Re: British Columbia Hydro and Power Authority (“BC Hydro”) Certificate of Public Convenience and Necessity for the Dawson Creek/Chetwynd Area Transmission Project. Project No. 3698640

REQUESTOR NAME: **Commercial Energy Consumers Association of British Columbia (CEC)**
 INFORMATION REQUEST ROUND NO: #1
 TO: **British Columbia Hydro and Power Authority (BC Hydro)**
 DATE: **August 24, 2011**
 PROJECT NO: **3698640**
 APPLICATION NAME: **Certificate of Public Convenience and Necessity for the Dawson Creek/Chetwynd Area Transmission Project**

Figure 2-3 Dawson Creek and Groundbirch areas Gas
Producer Forecast and Other Forecast (MW)

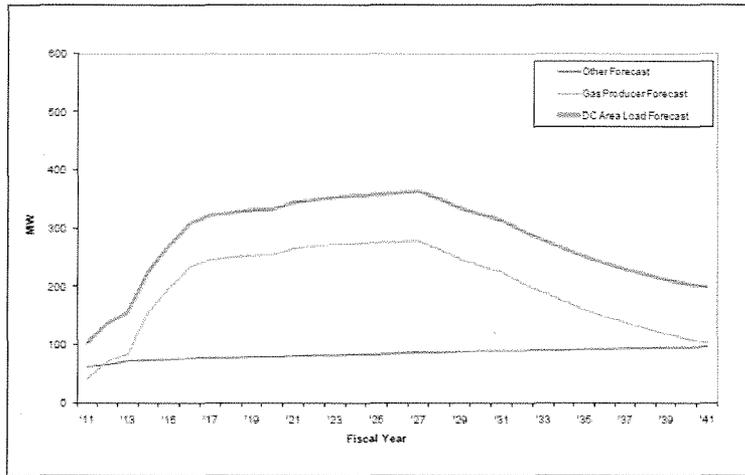
- 4.1 Please provide a specific point mapping of where the loads are anticipated to be within the Dawson Creek and Groundbirch areas.
- 4.2 To the extent a specific point mapping is not possible, with the current level of customer requests and intents currently being studied, please provide a breakdown between the Dawson Creek area and the Groundbirch area.

- 4.3 Please identify quantitatively how much of the Groundbirch area load could be served from the SNK substation and how these loads could be served from SNK.

- 4.4 Please describe why BC Hydro the BC Hydro area transmission planning does not expect that it is possible to service load from the SNK substation yet in a second stage for serving maximum loads options include 230KV transmission from SNK.

Figure 2-5 Load Forecast Scenarios

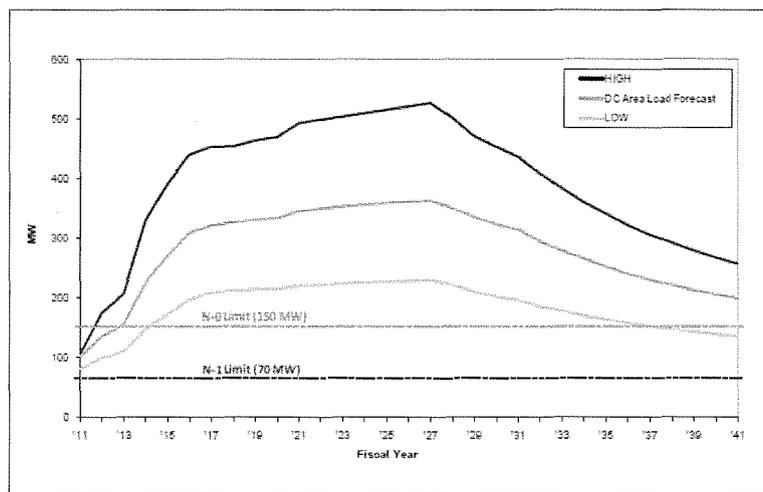
- 13.1 Please provide 3 graphs comparable to Figure 2-5, one each for Groundbirch loads, loads to be serviced from BMT and for load to be serviced from DAW.

Figure 4-5 Route Options East of Pine River SLS (West Segment)

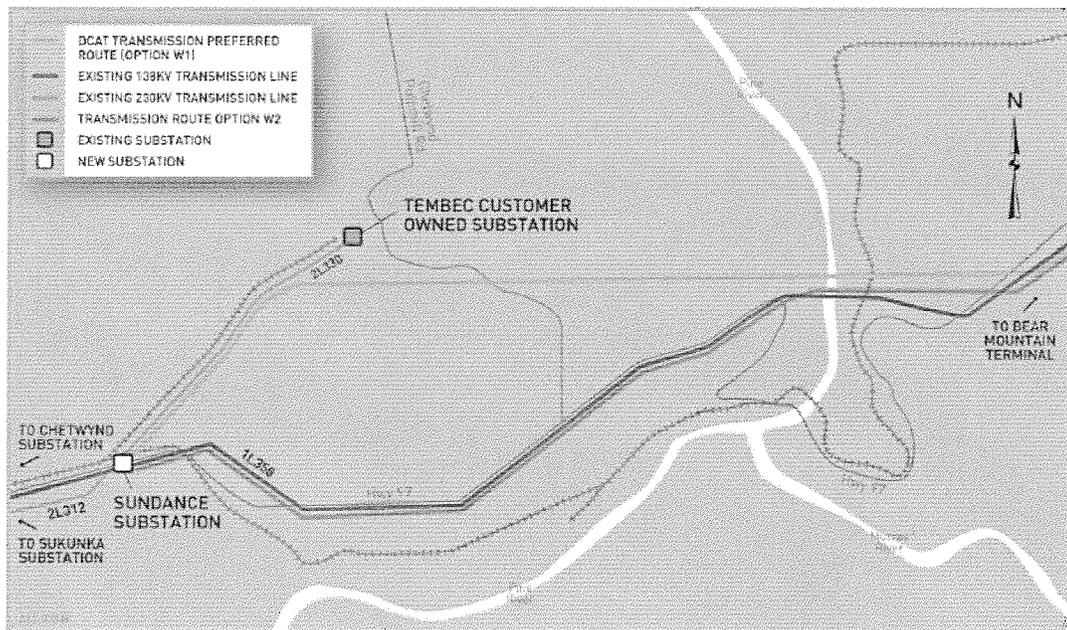
30.1 Please provide the scale for the transmission route maps.
